RE: Geotechnical Addendum
Proposed Residence
5818 West Mercer Way
Mercer Island, Washington

In accordance with your authorization, Cobalt Geosciences, LLC has prepared this letter to discuss global stability of the planned block wall-detention tank area west of the proposed residence. We have also included responses to City comments.

**Static Stability at Vault and Block Wall
FS 1.750**

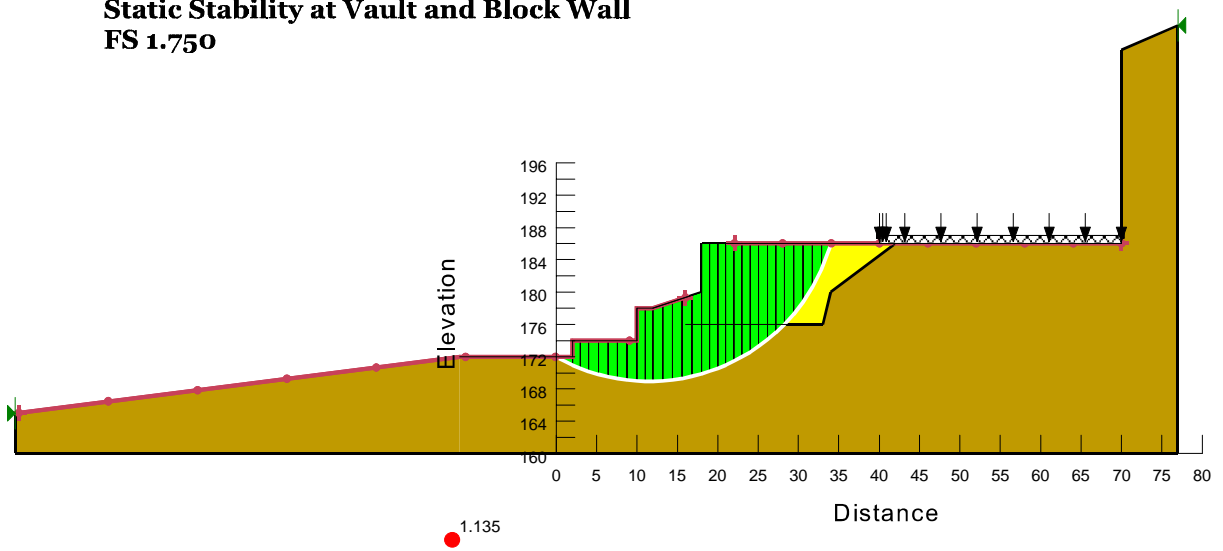
Cross Section	Static Factor of Safety	0.31g Seismic Factor of Safety
Global Stability with Deeper Block Wall	1.750	1.135

The analyses indicate suitable factors of safety can be achieved by utilizing a larger and deeper block wall system that penetrates through looser soils and embeds at the base of the elevation of the adjacent rockery (elevation 174 feet). This will require a double block wall with interlocking Ultra blocks for three rows (7.5 feet) with two single-depth blocks above this zone, similar to what is shown in the current plans. The only difference is additional blocks buried below the gravity wall shown on the civil plans. All voids behind and around blocks should be filled with 5/8 to 2 inch clean angular rock. A footing drain is necessary to alleviate any buildup of surface or groundwater.

**Soldier Pile
Wall with
Tiebacks**

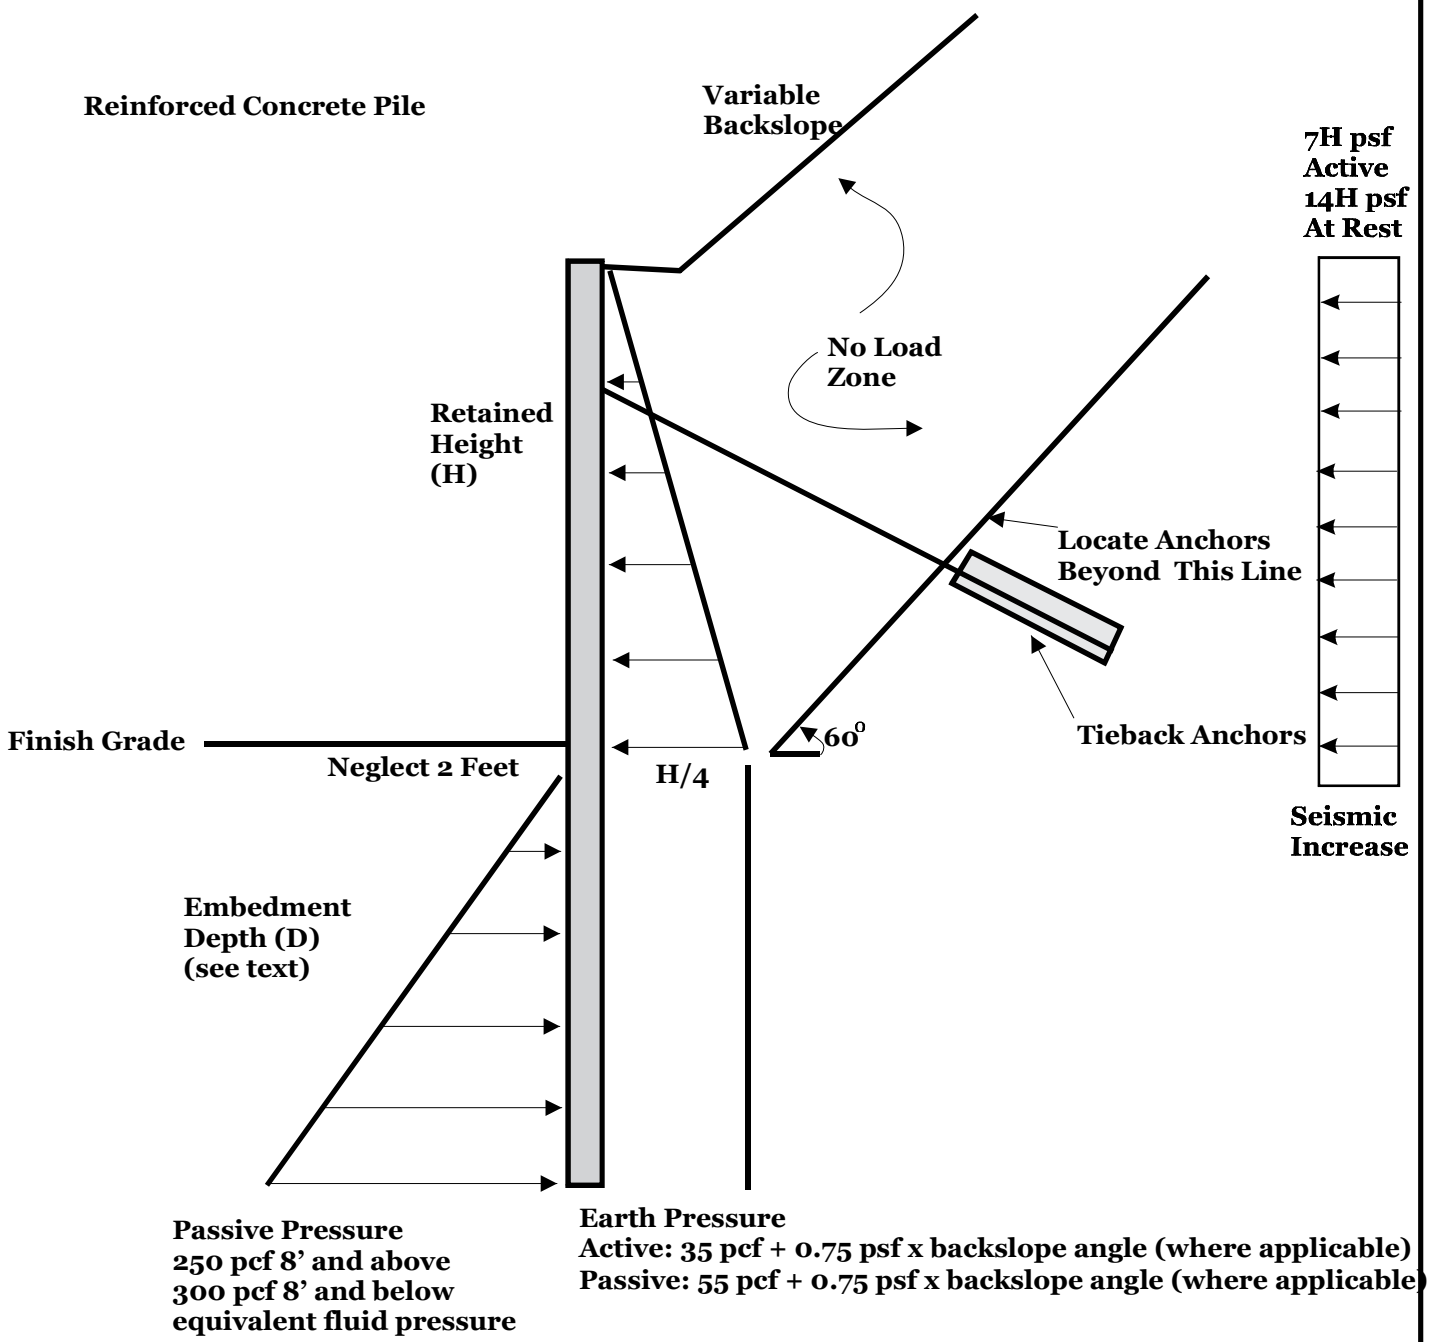
We have included pressure diagrams as they pertain to single and multiple rows of tieback anchors. Sites underlain by very fine grained soils can require additional 'roughening' of the drilled tieback holes with the bit. Post grouting could be necessary and we recommend load testing at least one anchor soon after installation to verify suitability of the drilling and grouting process.
